# Statement

We, NETPRISMA INC., declare on our sole responsibility for the product of LCUK54-WWD (FCC ID: 2BEY3LCUK54WWDA) & LCUK54-WRD (FCC ID: 2BEY3LCUK54WRDA) as below:

| Parameter           | LCUK54-WRD                                                                         | LCUK54-WWD                                                                          |
|---------------------|------------------------------------------------------------------------------------|-------------------------------------------------------------------------------------|
| Component Placement |   |   |

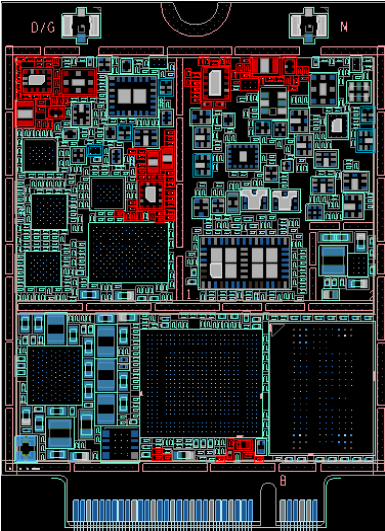
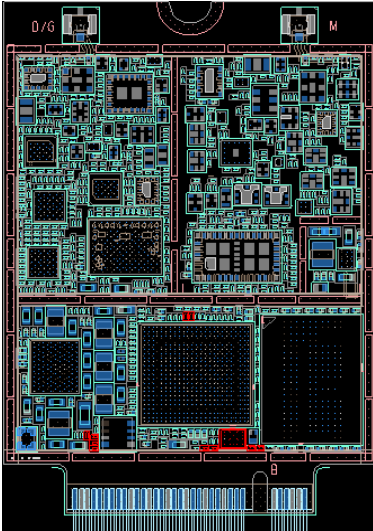
- PCB Layout changes: No
- Antenna change: No
- PA change: NO
- Adding or reducing materials: Yes (Compared with the prototype LCUK54-WRD, the LCUK54-WWD adds B42/43/48 related components.)
- Shield case: Yes
